Technical Car Construction Regulations

Rule Changes for 2017 & Rule Clarifications

Version 1.1 FINAL – 19th October 2016

Author: Adrian Blackwell
BriSCA F2 Chief Technical Consultant

18. CLARIFICATION – Windscreen Mesh

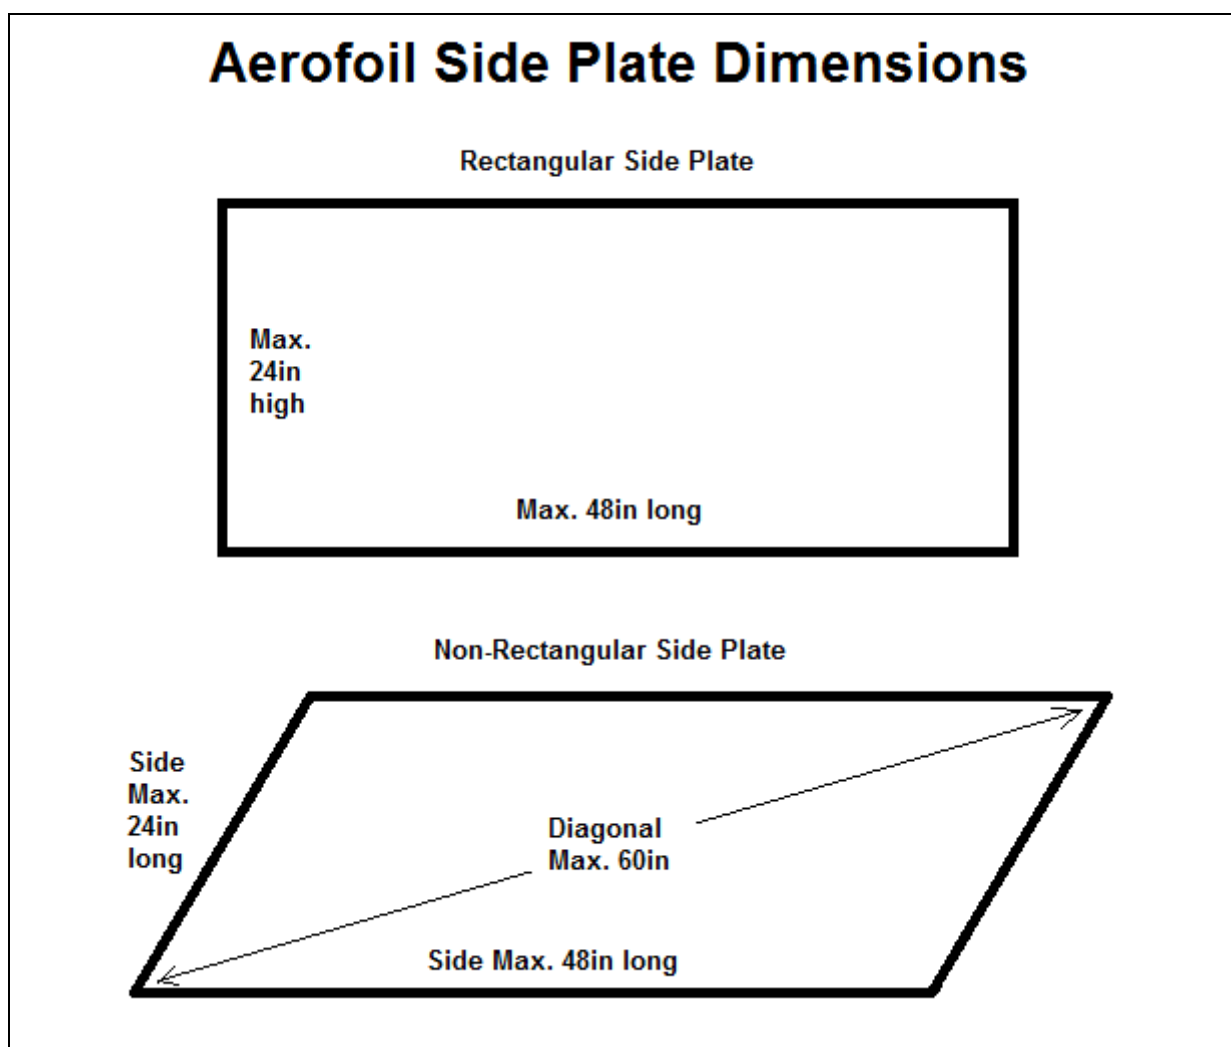
- **The use of cable-ties (whether metal or plastic) is NOT permitted for fixing the windscreen mesh to the car.**
- The windscreen mesh MUST be securely fitted by welding, or through the use of metal fixings such as nuts and bolts, “U”-bolts, or “Jubilee” clamps.
- If metal fixings are used then a MINIMUM of 4 fixings, 1 per corner of the mesh, are required.
